ECE/TRANS/WP.29/2007/2/Corr.1
27 February 2007

PROPOSAL FOR SUPPLEMENT 4 TO THE 10 SERIES OF AMENDMENTS TO
REGULATION No. 13
(Braking)

Corrigendum

DIAGRAM 1

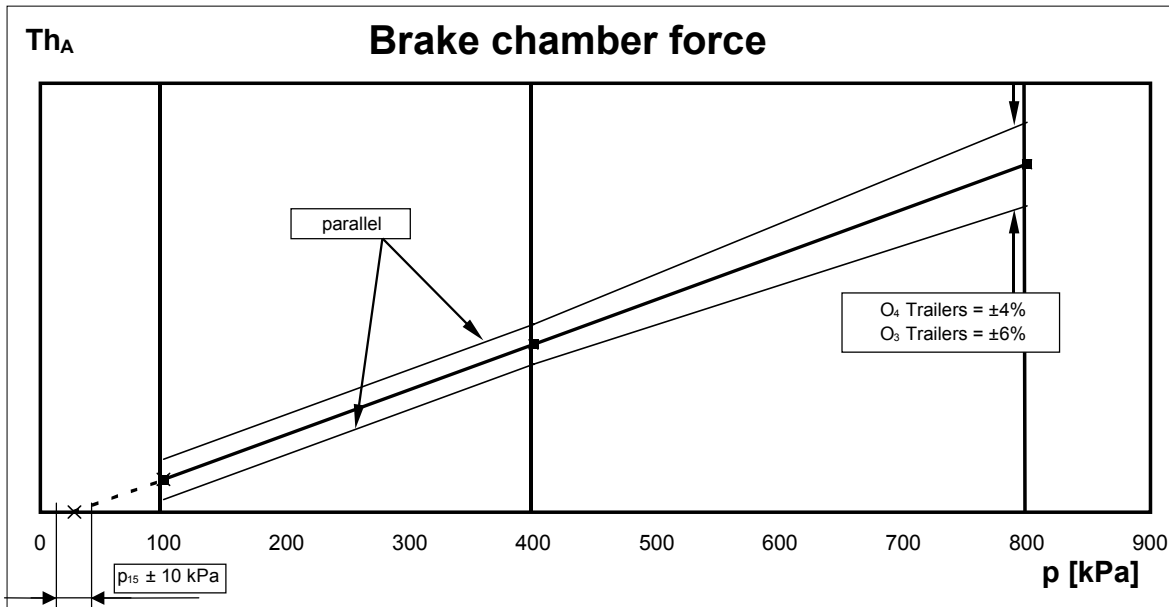
Page 216, Annex 19, diagram 1, replace the existing figure by the following one:

DIAGRAM 2

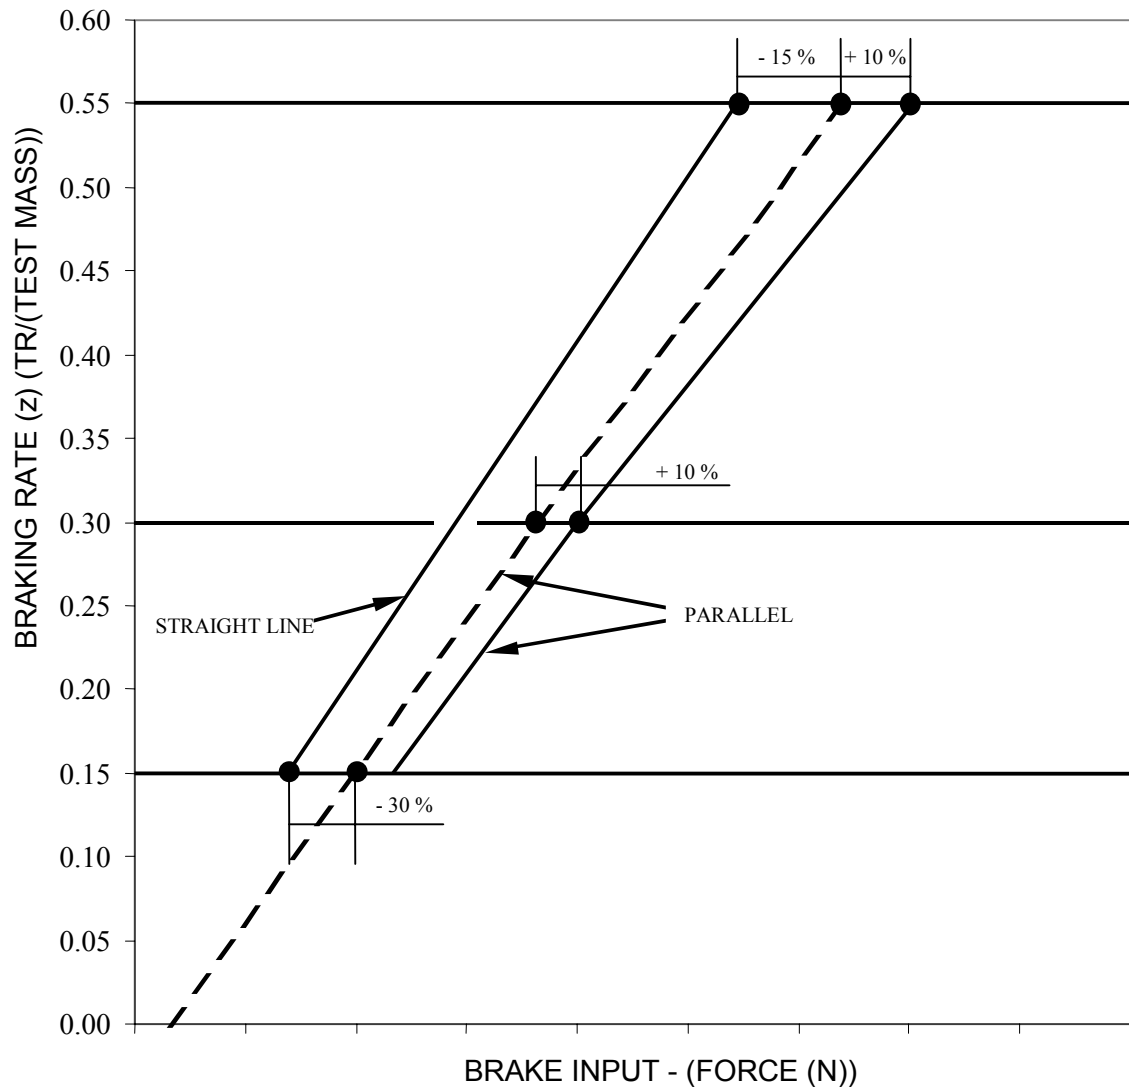
Page 230, Annex 19, diagram 2, replace the existing figure by the following one:
